## CITY OF MARLBOROUGH MEETING POSTING

Meeting: **Planning Board**  
Date: **December 21, 2020**  
Time: **7:00 PM**  
Location: **REMOTE MEETING NOTICE**

Subject: Four-Lot Subdivision, 76 Broad Street, Marlborough, MA  
**Response to Engineering Division review comments**

DEFINITIVE SUBDIVISION PLAN

### PETTES ROAD PROFILE

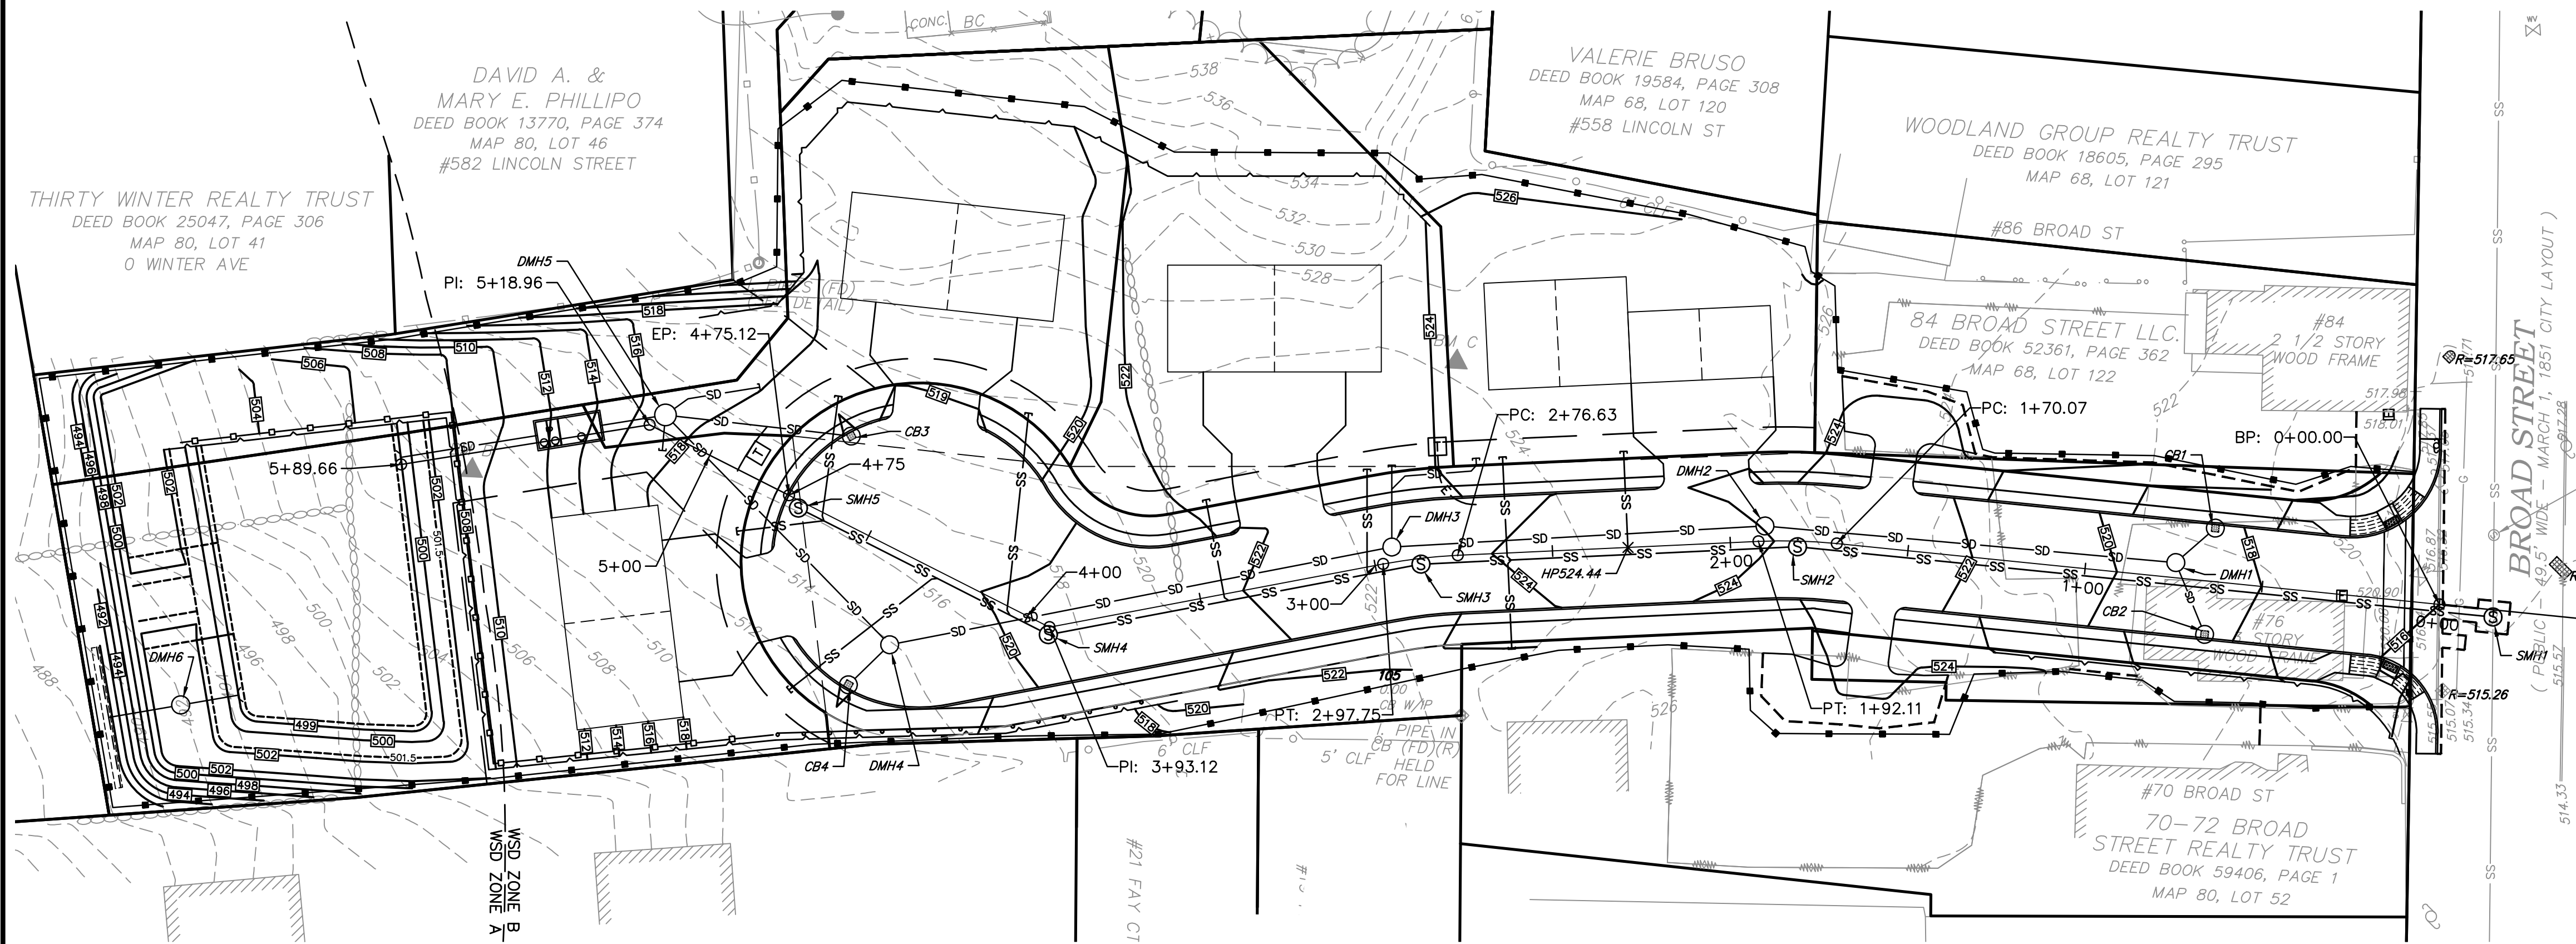
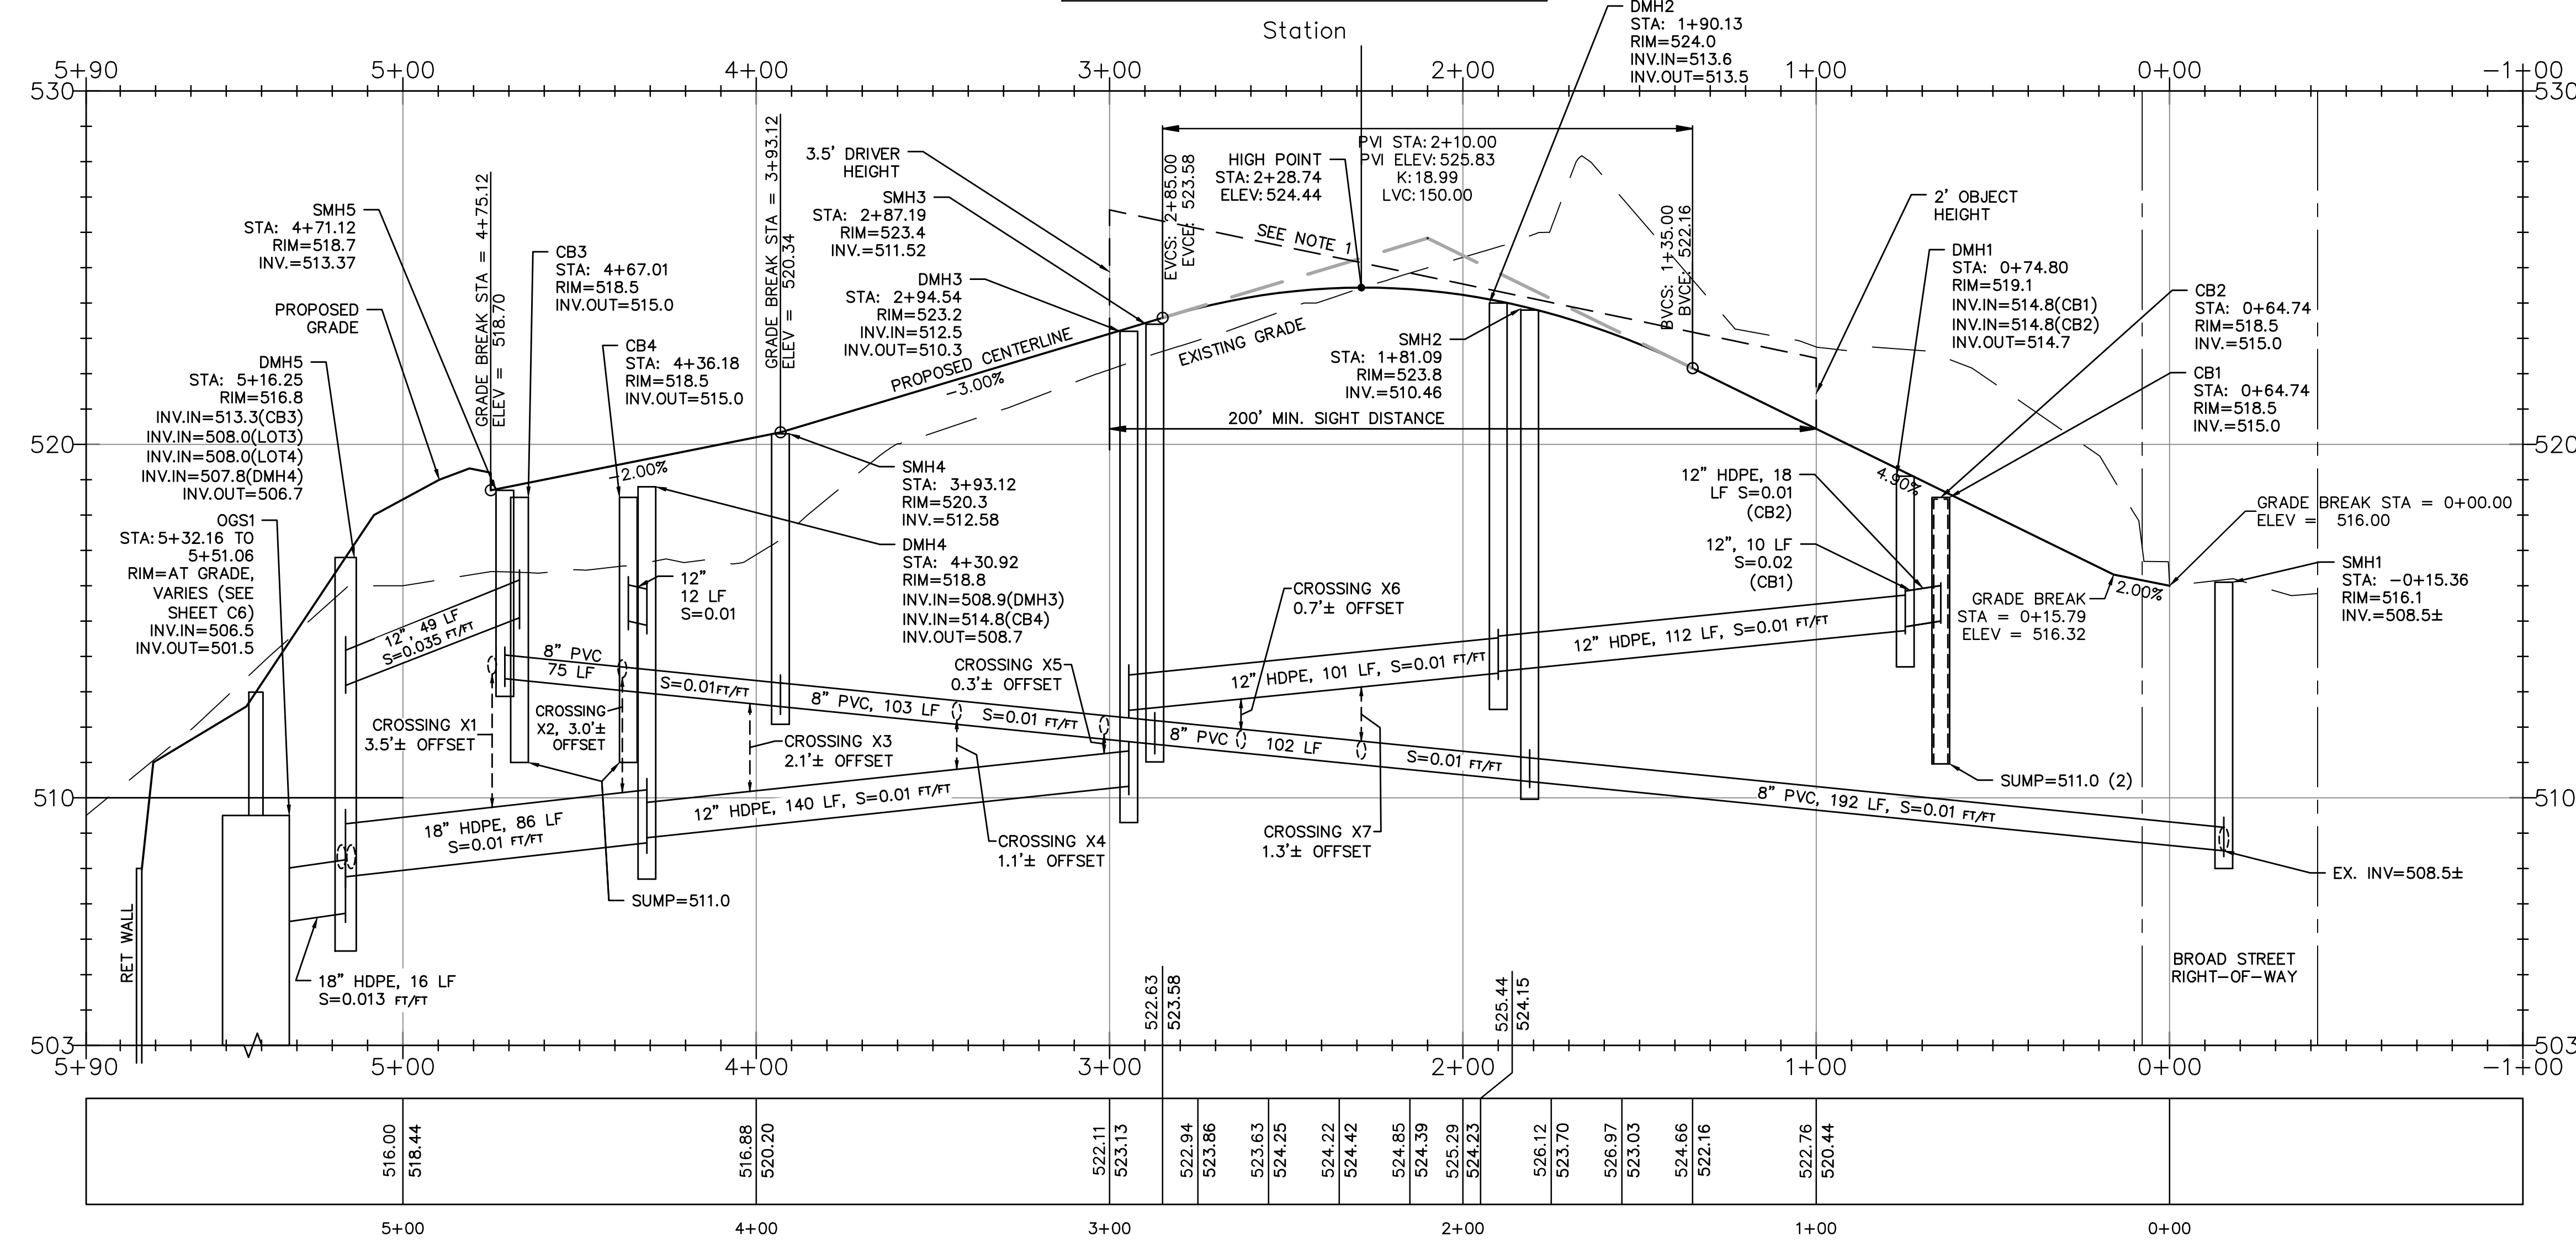
There is a grade change from 2% to 4%, where a vertical curve is required for this transition.

- The Plan and Profile Plan should show the following:
  - Stationing at all drainage structures and sewer structures (need to draw in OGS1 to scale)
  - Final grades along vertical curves at 20-foot intervals
  - Type of [pipes] proposed for drainage and sewer

- Remove the "existing trees" from the roadway.

**Response: We respectfully request a waiver from bylaw §A676-11.D(3) (see Requested Waivers, page 2) to allow a grade change from 2% to 4.9%.**

To provide a shallower cross slope for the proposed crosswalk, a center-line grade of 2% is proposed from the upgradient edge of crosswalk to the existing gutter line in Broad Street. The proposed crosswalk is about 10 feet away from the Broad Street gutter line, moving pedestrians away from the thru traffic. The 2% cross slope would make the crosswalk more in line with ADA and MAAB standards. This item was discussed with City Engineer Thomas DiPersio.

**Response: The Plan and Profile (C8) has been revised.**

**Response: The Plan and Profile (C8) has been revised.**

LAYOUT: ESC

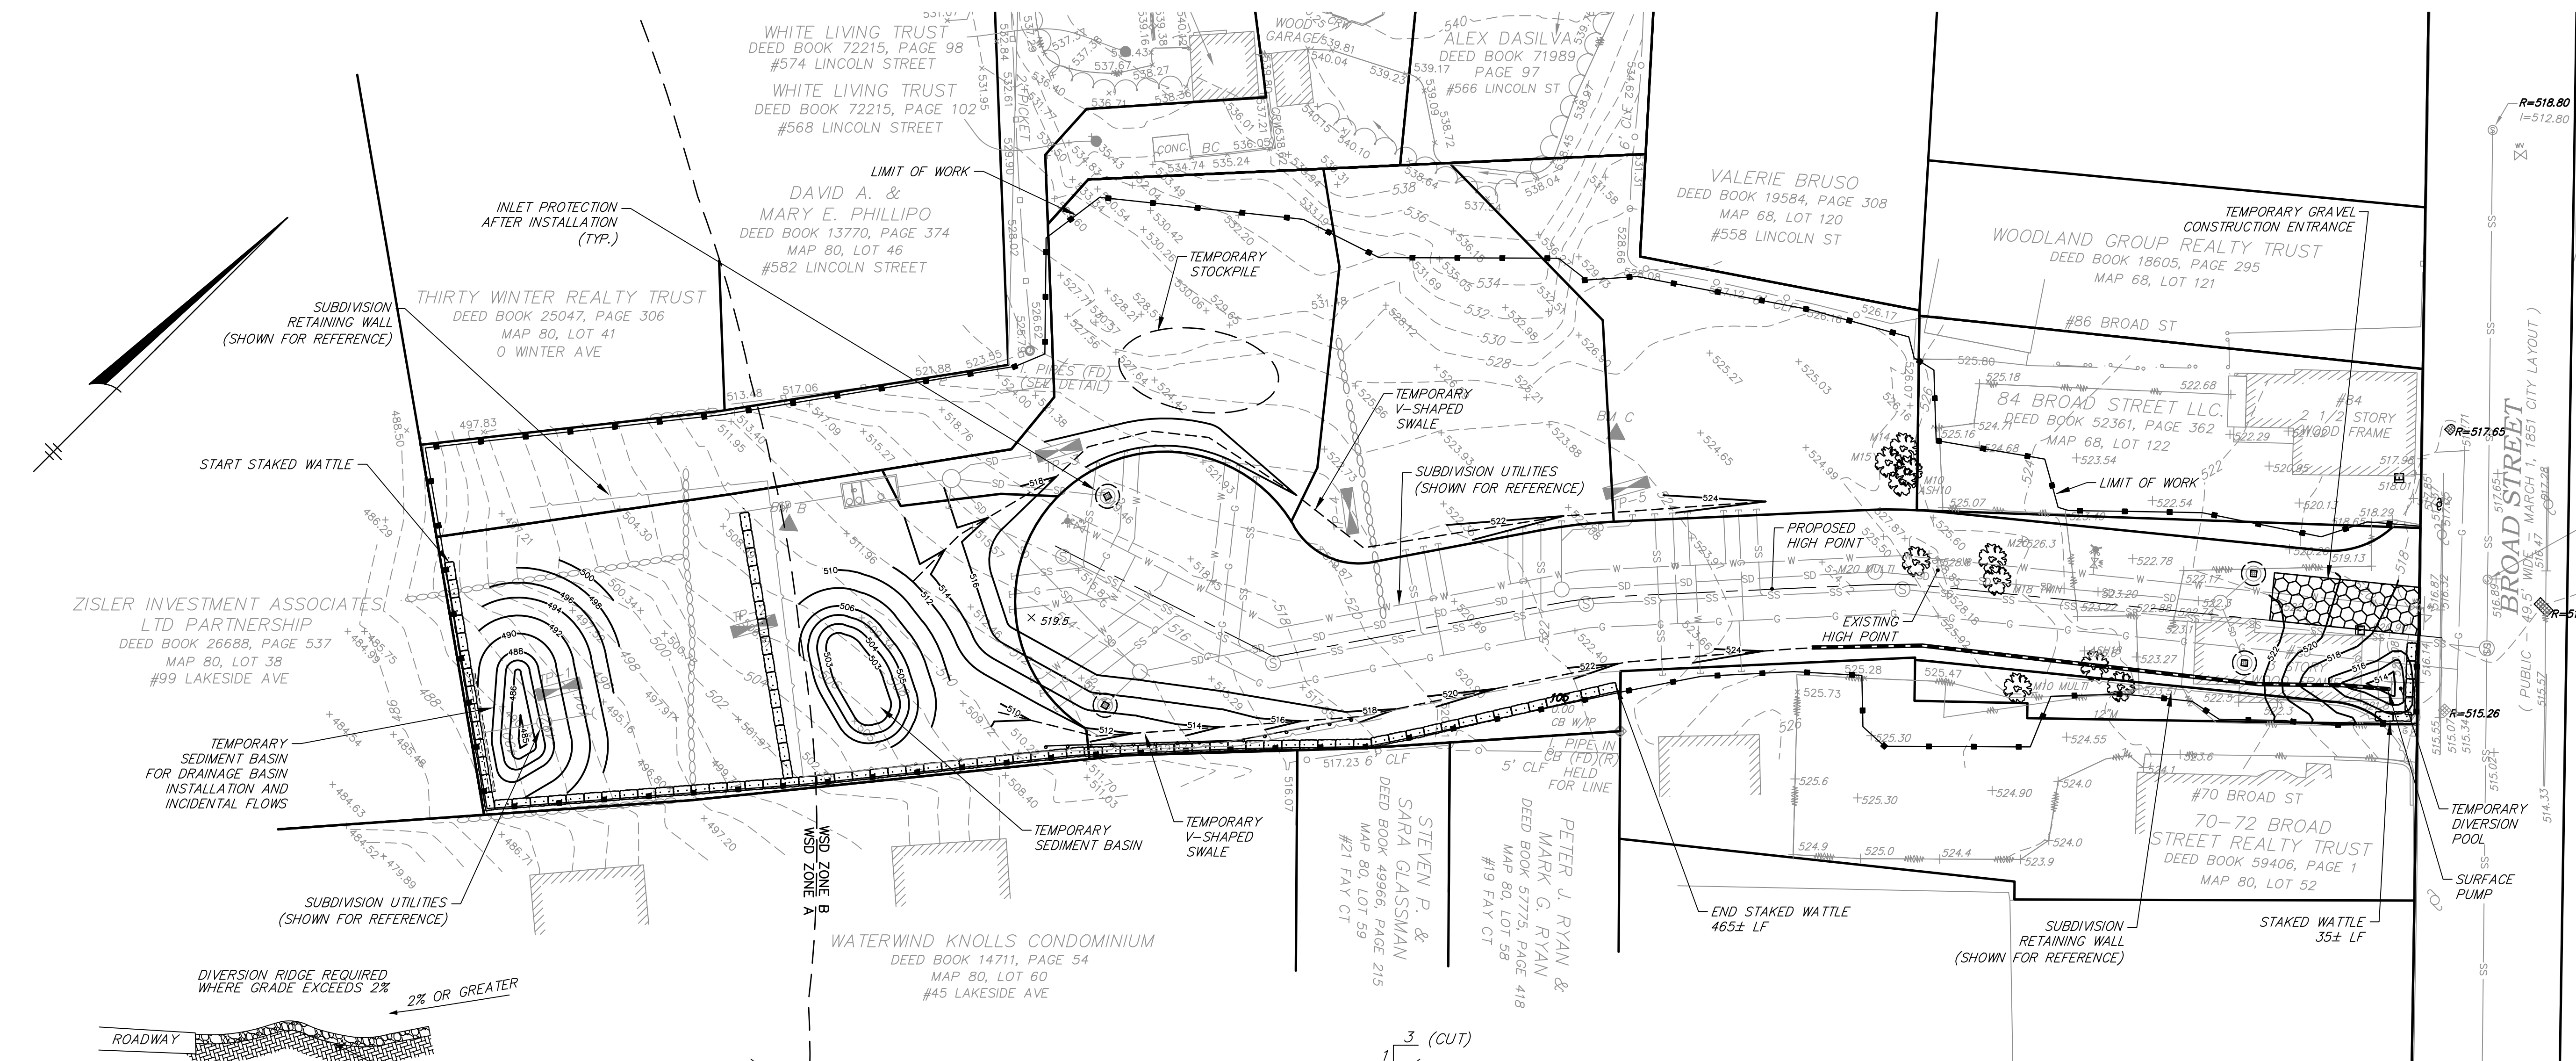
- The location and/or the configuration of the proposed temporary sediment basin should be revised to account for the fill that will be installed at the end of the roadway.

**Response: The Erosion and Sediment Control Plan (C9) has been revised.**
